ALTERATION TO A HISTORIC PROPERTY STAFF REPORT

Site / District(s): 9-11 Aldersey Street / LHD

Case: HPC 2013.085

Legal Notice: Restore and alter the existing historic structure; construct two additional residential

Photo 2012

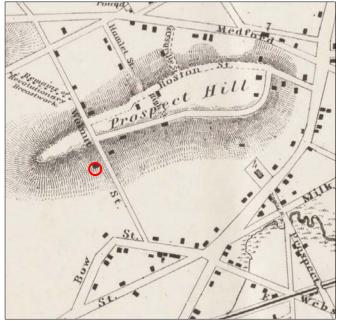
The proposal requests to remove the inappropriate portions that enclose the bottom portion of the existing front porch and replace this with appropriate railings and balusters.

The proposal requests to remove the fire escape on the primary façade of the building.

The enclosure of the front porch is a later addition that is not stylistically appropriate to the structure and should be reversed, as should removal of the fire escape.

Staff determines that a portion of the project for which an application for a Historic Certificate has been files is appropriate for and compatible with the preservation and protection of the Aldersey-Summit Local Historic District. Therefore, Staff recommends the Historic Preservation Commission grant Gerard Meehan, Trustee for G&T Realty Trust, a Certificate of Appropriateness to remove the existing clapboard porch rail and fire escape and to replace the railing with a style appropriate railing and balusters.

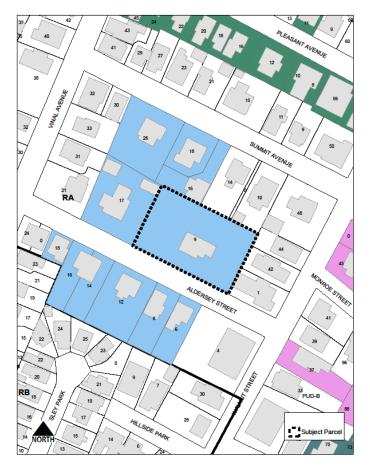
The site plan illustrates that the walkway to the historic structure would change from being located at the side of the porch to the center of the porch. As this would modify access to the building, research should be done to determine if the porch may have had a center entry at one point. Placement of the front door on the center of the façade and the original Greek Revival style suggest that the original access may have been centered. However, as the current access is

clearly from the side of the porch, one solution would be to add the center access yet maintain the side access.

The addition of parking for 22 vehicles and the amount of space devoted to vehicular movement would significantly alter the circulation of the site. Staff recommends significantly reducing or even eliminating the surface parking as well as to remove one of two driveways in an effort to maintain as much existing open space on-site as possible. While any changes to the site will likely negatively affect the integrity of the site, and therefore the historic structure, reducing the on-site parking and hardscape minimizes the reduced integrity of the site and structure.
